**NOTIFICATION FORM FOR THE NOTIFICATION OF DANGEROUS PRODUCTS
TO THE AUTHORITIES BY PRODUCERS OR DISTRIBUTORS**

SUBJECT : NQR90 seatbelt warning light does not illuminate

SUBJECT: X6764 Recall Campaign; Q95 Seat Belt Warning Light harness modification

Procedure for Seat Belt Warning Light harness modification

Wiring Diagram before the modification (wrong circuit)

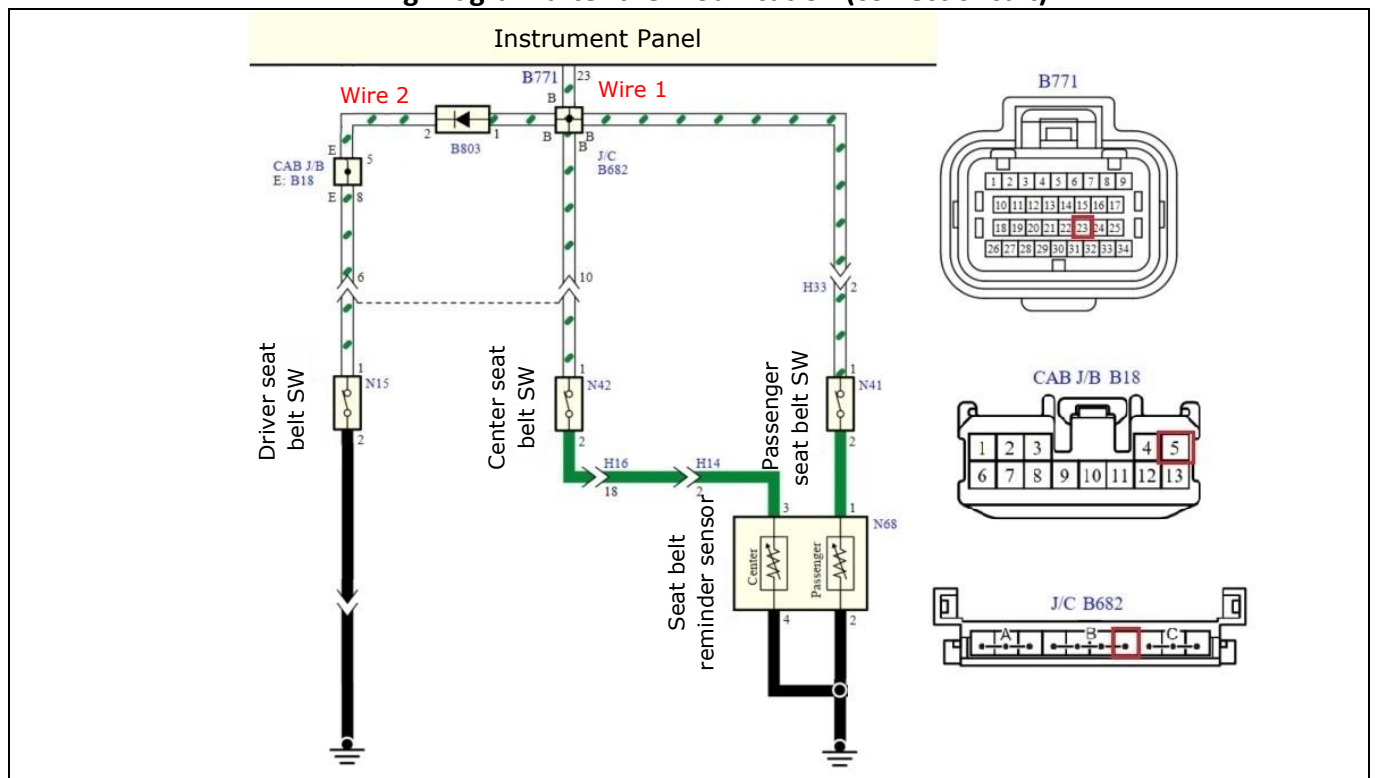
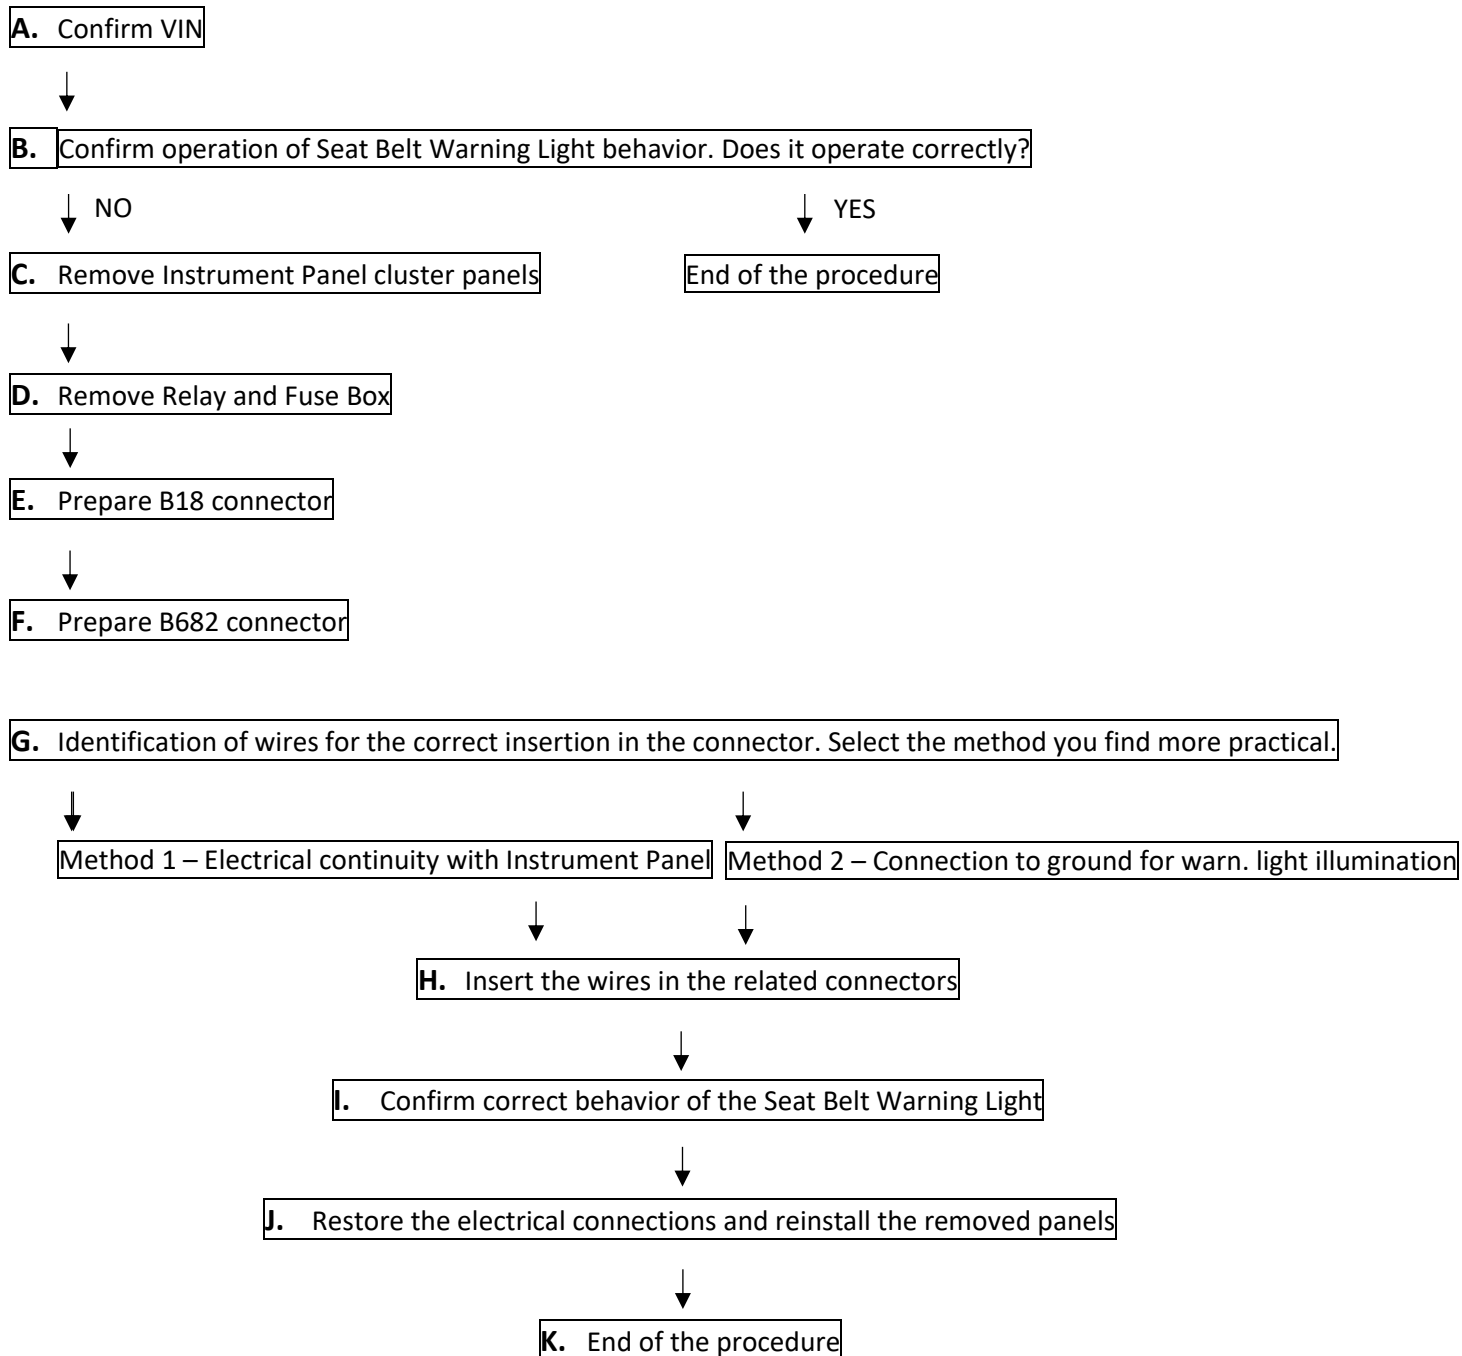
Isuzu found that seatbelt warning does not illuminated when the passenger sits in the seat in assembly line in Turkey.

This does not comply with UN regulation No.16.

Improper cab harness design by vehicle manufacturer.

Cab harness circuit modification.

Wiring Diagram after the modification (correct circuit)

- 1) Insert Wire 1 into B682 junction connector (for the insertion position of the wire, refer to the picture “Wiring Diagram after the modification (correct circuit)” at page 3).
- 2) Insert Wire 2 into B18 junction connector (for the insertion position of the wire, refer to the picture “Wiring Diagram after the modification (correct circuit)” at page 3).
